RE: IFB DRR21001 Bonzi Sanitation Landfill Closure Construction

**Addendum No. 4
To the Invitation for Bids (IFB), DRR21001**

**Irrigation Study Map
Bonzi Sanitation Landfill**

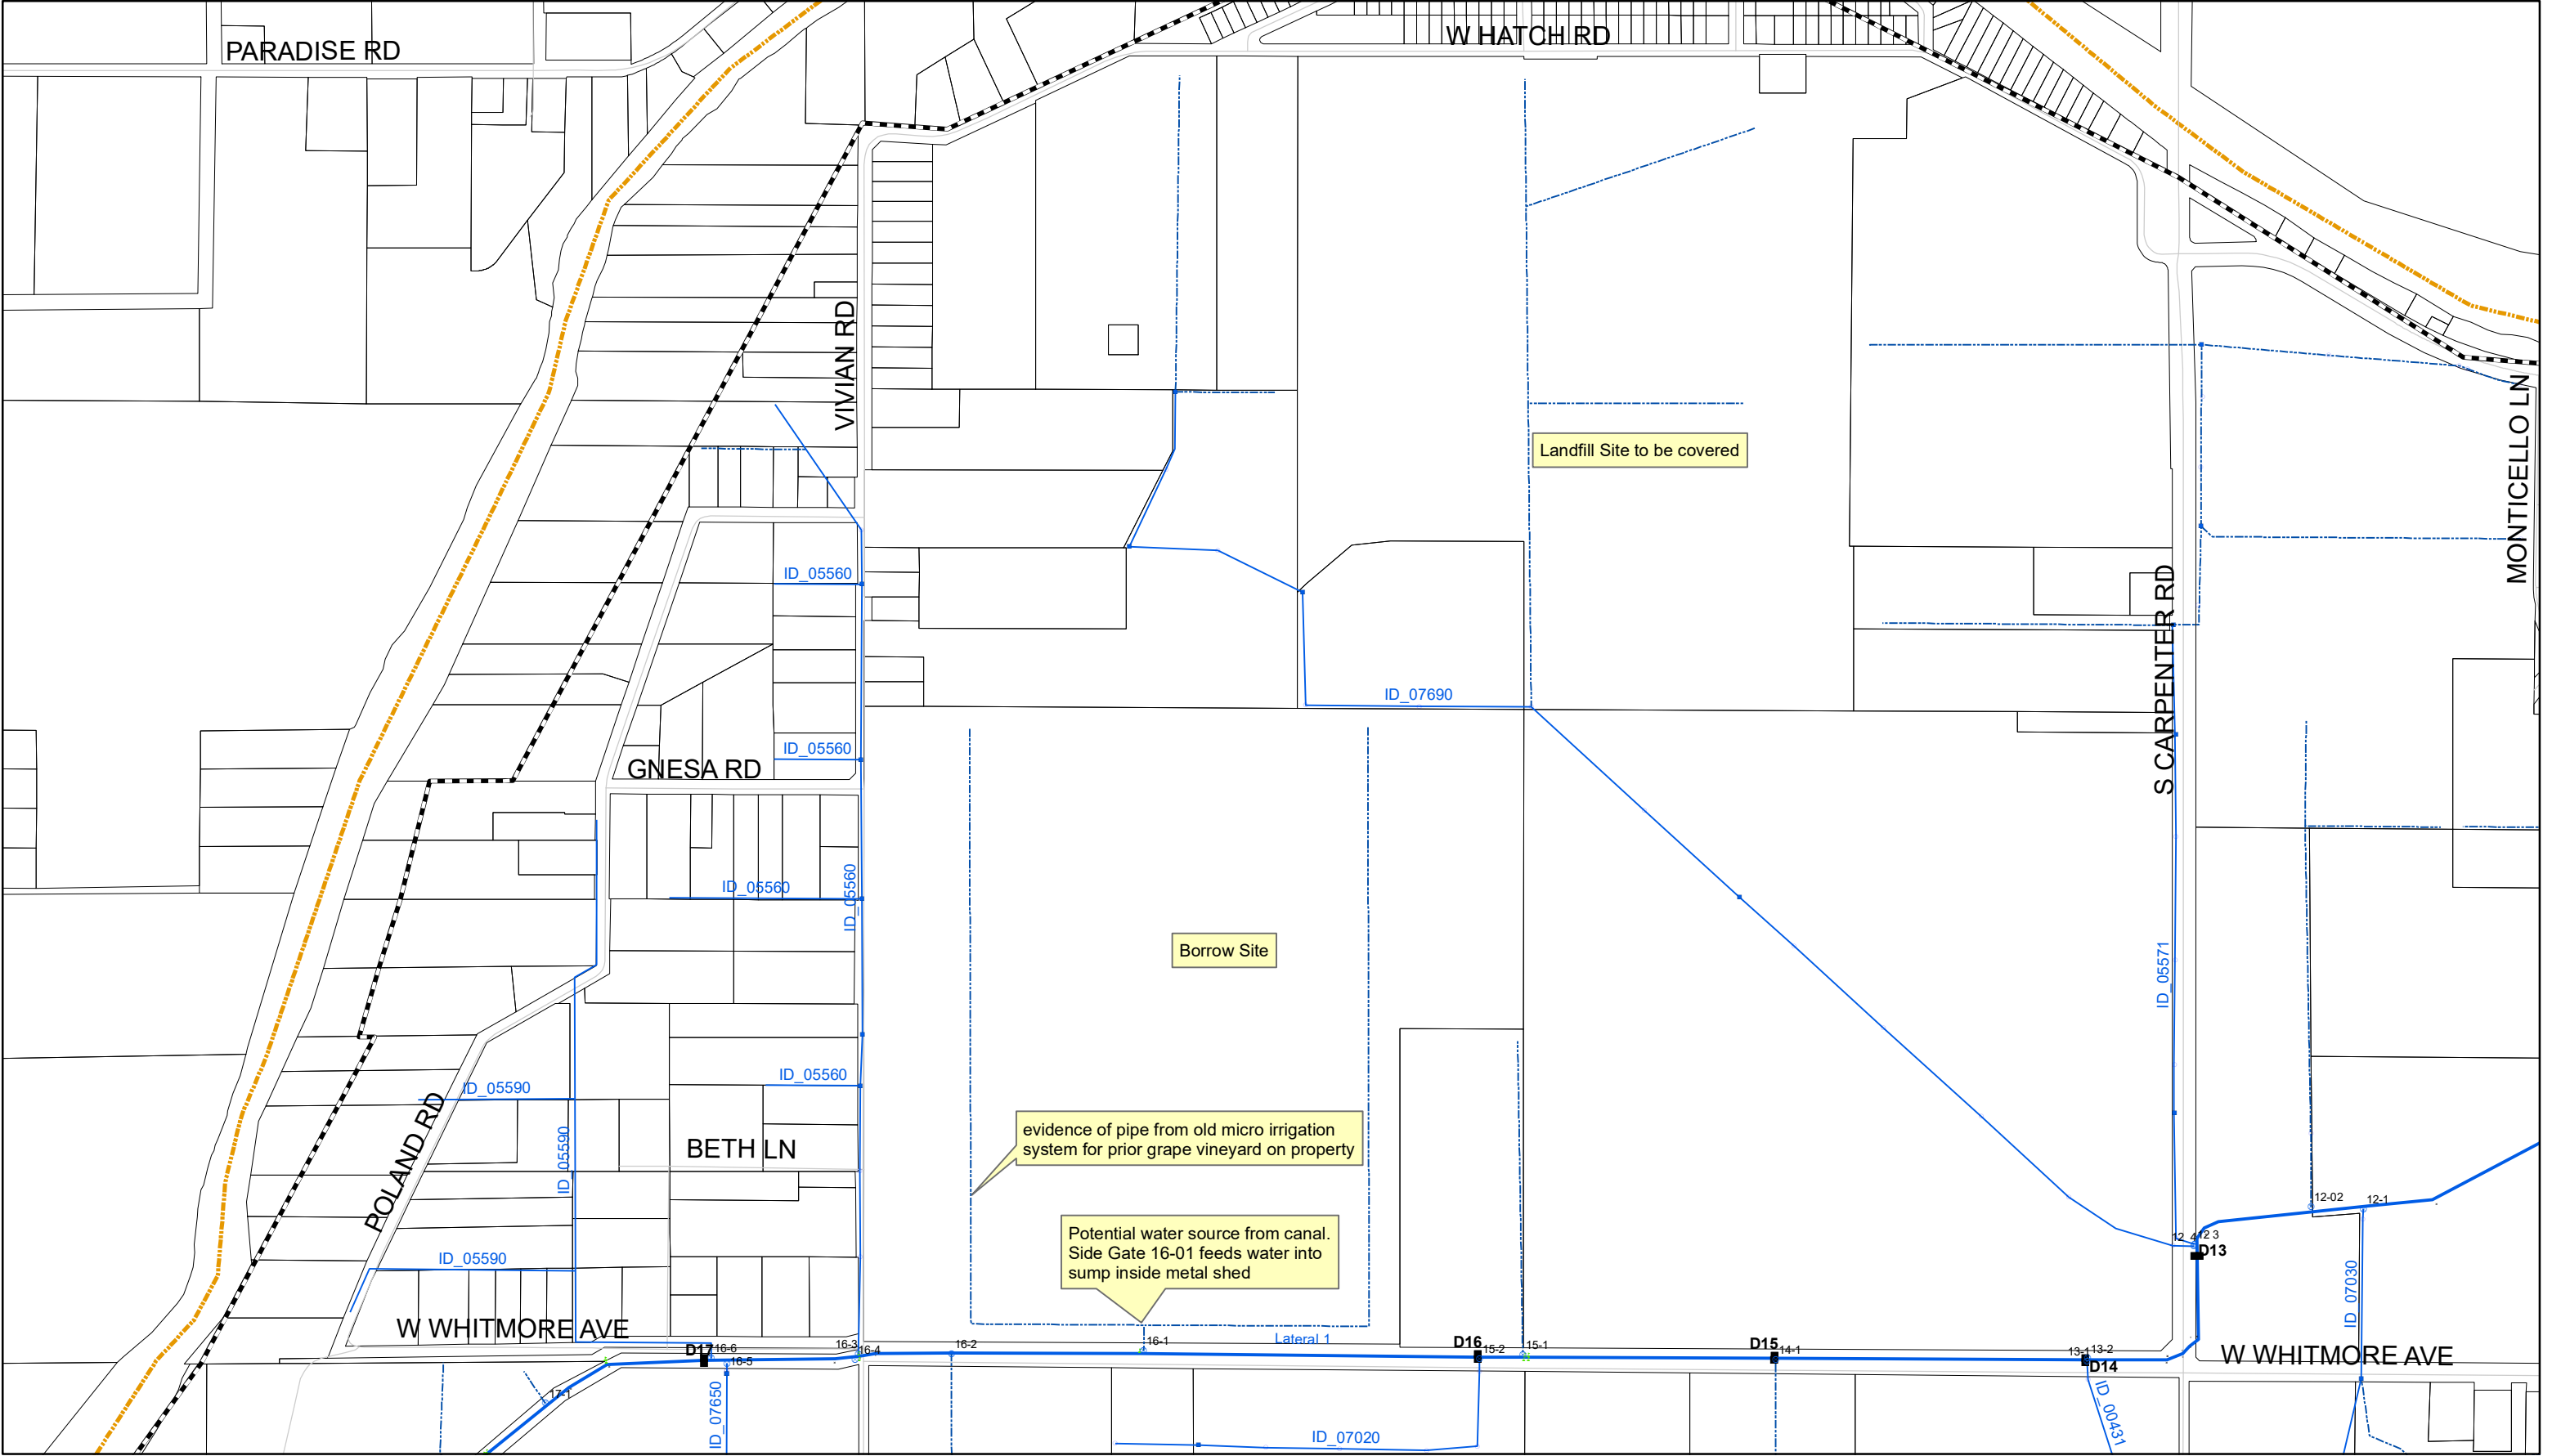
1. Attached is a list of all businesses who have expressed an interest in the contract to date (Attachment 1).
2. CalRecycle is issuing Addendum No. 4 to respond to the following questions received during the Questions and Answers period.
3. Attached as part of Addendum No. 4 is the "TID Water & Power Irrigation Study Map Bonzi Sanitation Landfill" Turlock Irrigation District Map.
